# EXHIBIT 1 DEPARTMENT OF COMMUNITY DEVELOPMENT STAFF REPORT TO THE CITY OF MILL CREEK PLANNING COMMISSION

**NAME OF PROJECT:** Preliminary Plat of Creekside West (Planned Area Development),

File No. PL2017-0022

## **Exhibit 1b Preliminary Plat**

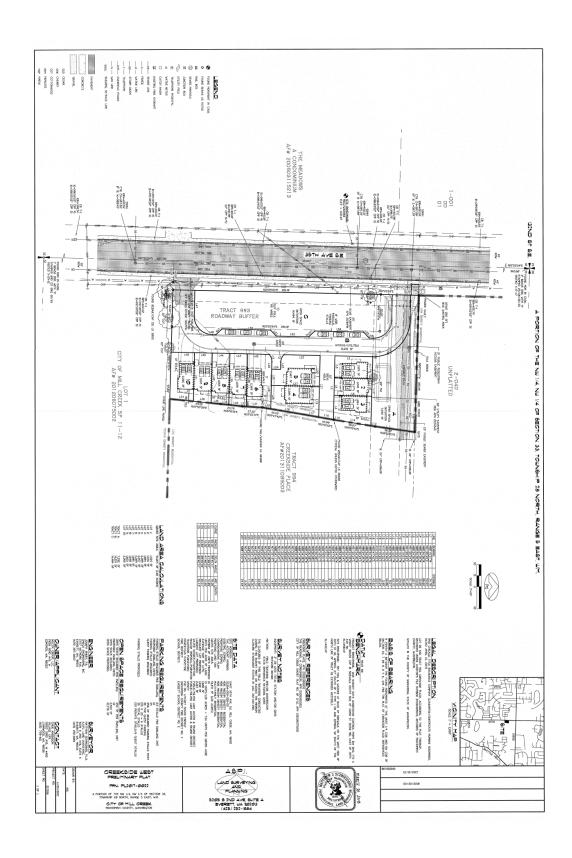
- Required front yard setback: Allowable range of 15 feet to 20 feet; however, garages shall be
  constructed a minimum of 20 feet from the sidewalk in such a manner that keeps sidewalks
  and pedestrian ways clear of vehicles.
  - The applicant is requesting a reduction in the front yard setbacks for the garages to 10 feet for Lots (Lots 1-3).
- Required side yard setback of 10 feet between the ends of buildings for duplexes, 15 feet between the ends of buildings containing three or more units;
  - No reduction.
- Required rear yard setback: 10 feet for structures on platted lots, 25 feet from the perimeter of project.
  - The applicant is requesting a reduction in the rear yard setback to 10 feet for Lots 6-10 from 25 feet.

The requested building setback reductions meet the intent of the code and do not impact adjacent land uses or residences. These modified setbacks are illustrated on the preliminary plat map. The proposed setbacks are necessary to allow more flexibility in the design of the homes, low impact development techniques (rain gardens) and to provide parking. In addition the rear setbacks allow 12 parking spaces above the minimum number required by code. In summary, staff supports the setback modifications as requested by the applicant as the reductions meet the intent of the code and the applicant is able to meet the zoning regulations and design standards.

- 1. Development shall occur as portrayed on the Preliminary Plat Map, except as may be modified by the Hearing Examiner following the open record hearing, per MCMC Chapter 4.34.
- 2. Building setbacks on the lots shall be as required by code with the following exceptions:

Front yard setbacks:

• 10 feet for Lots 1-3

Rear yard setbacks:

- 10 feet for Lots 6-10
- 3. All utility, stormwater, drainage, maintenance, and landscaping buffers/easements, together with attendant restrictions and conditions, shall be portrayed on the final plat. Building setback lines shall be shown on the face of the final plat.
